Model: Model U-C1 LCT (PS520)		Date: 22-Mar-05	No.: MB457001
Modified Article: Stand		Prepared by: S. Tomoe	
From: 1st Tech. Support Sec. Service Support Dept.			
Reason for Modification:	<input type="checkbox"/> Parts catalog correction <input type="checkbox"/> To facilitate assembly <input type="checkbox"/> Part standardization	<input checked="" type="checkbox"/> Vendor change <input type="checkbox"/> To improve reliability <input type="checkbox"/> Other	<input type="checkbox"/> To meet standards ()

Model: Model U-C1 LCT (PS520)		Date: 22-Mar-05	No.: MB457002
Modified Article: Rear Left Stand Bracket		Prepared by: S. Tomoe	
From: 1st Tech. Support Sec. Service Support Dept.			
Reason for Modification:	<input type="checkbox"/> Parts catalog correction <input type="checkbox"/> To facilitate assembly <input type="checkbox"/> Part standardization	<input type="checkbox"/> Vendor change <input type="checkbox"/> To improve reliability <input checked="" type="checkbox"/> Other	<input type="checkbox"/> To meet standards ()

Model: Model TH-C1		Date: 6-Apr-06	No.: RB156027
Subject: LCT Jam or Noise		Prepared by: H.K.	
From: 1st Tech. Support Sec. Service Support Dept.			
Classification:	<

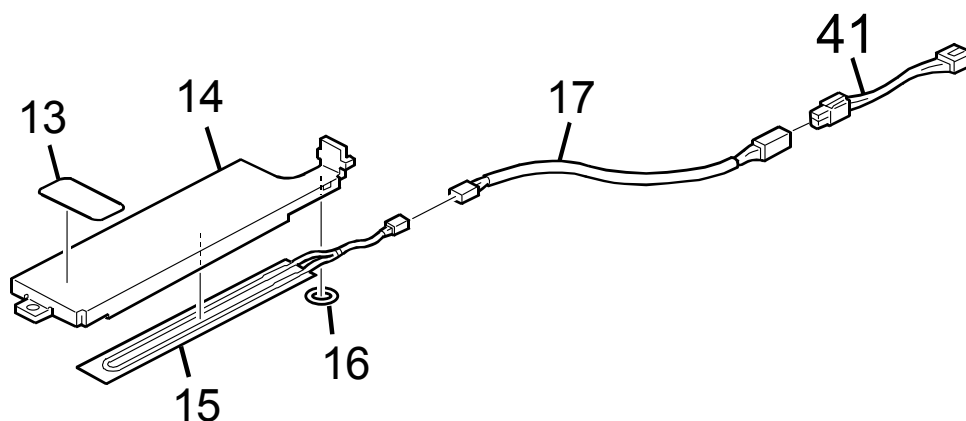
- 1) The material of the I/F harness (heater harness) was changed to a more environmentally-friendly type.
- 2) A relay harness was added (heater sub harness).

- 1) This is part of Ricoh's ongoing application of in-house environmental standards.
- 2) So that the LCT can connect to the mainframe PSU.

Note: The position of the LCT connector on the TH-C1 PSU is different from the previous model.

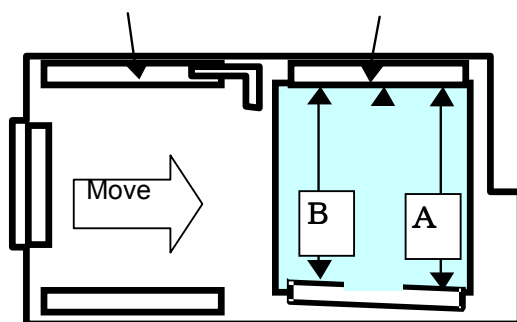
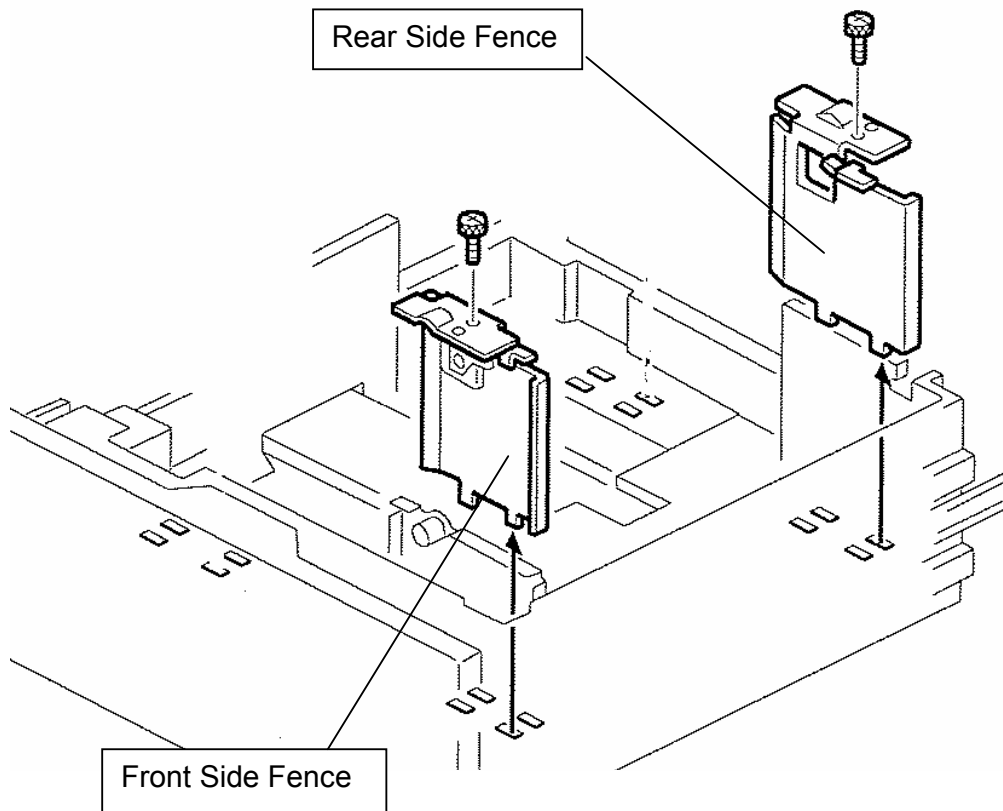
When the paper stack is moved from the left to the right in the LCT, the first sheet of the paper stack in the LCT jams, or noise occurs and the paper is not fed.

- The distance between the side fences is narrow. As a result, the paper is not moved correctly to the right side of the LCT, and the timing belt is overloaded.
- The paper is wider than specification or has burrs on its edge

1. The distance between the side fences was increased by 0.5mm.
 - The length of the front side fence was changed (P/N B1809902)
2. The distance between the side fences is checked on the production line.
 - Cut-in S/N:

1. The distance between the side fences was increased by 0.2mm
- The positions of the screw holes were moved 0.1mm.
2. The distance between the side fences is checked on the production line.

1. Replace the front side fence with **B1809902** (production line temporary solution).
- Or,
2. Replace the front side fence and rear side fence with **B6002645** and **B6002655**.

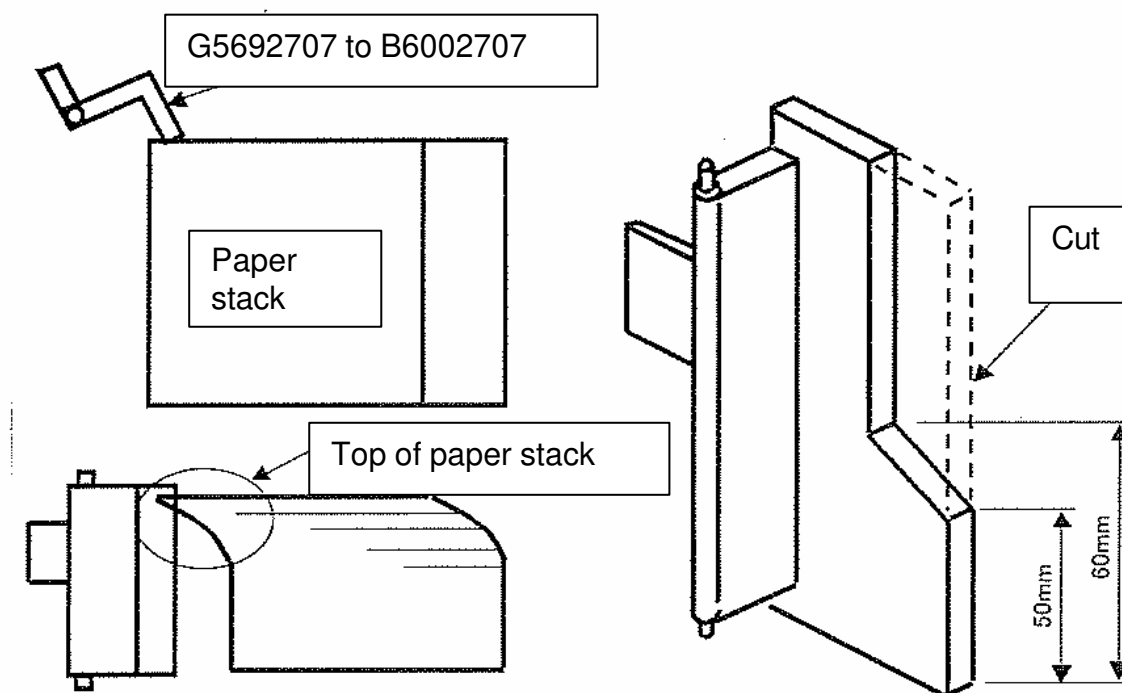
Change: The shape of the end fence was changed.

Reason: To improve the accuracy of moving the paper stack from the left side to the right side of the tandem tray.

- This will also help to prevent SC503 occurrences.
- If the top of the paper stack collapses (see the illustration below), the top of the paper stack pushes the end fence open.

Model: Model U-C1 / TH-C1 LCT (PS520)	Date: 28-Jul-06	No.: MB457009a
---------------------------------------	-----------------	----------------

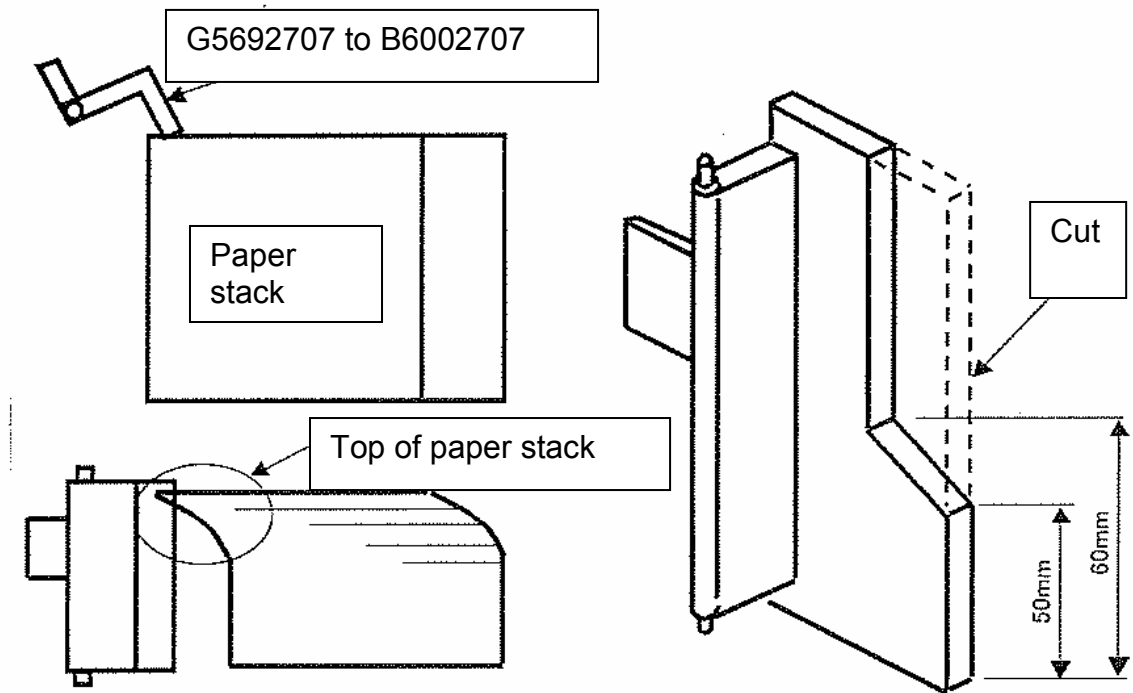
Change: The shape of the end fence was changed.

Reason: To improve the accuracy of moving the paper stack from the left side to the right side of the tandem tray.

- This will also help to prevent SC503 occurrences.
- If the top of the paper stack collapses (see the illustration below), the top of the paper stack pushes the end fence open.
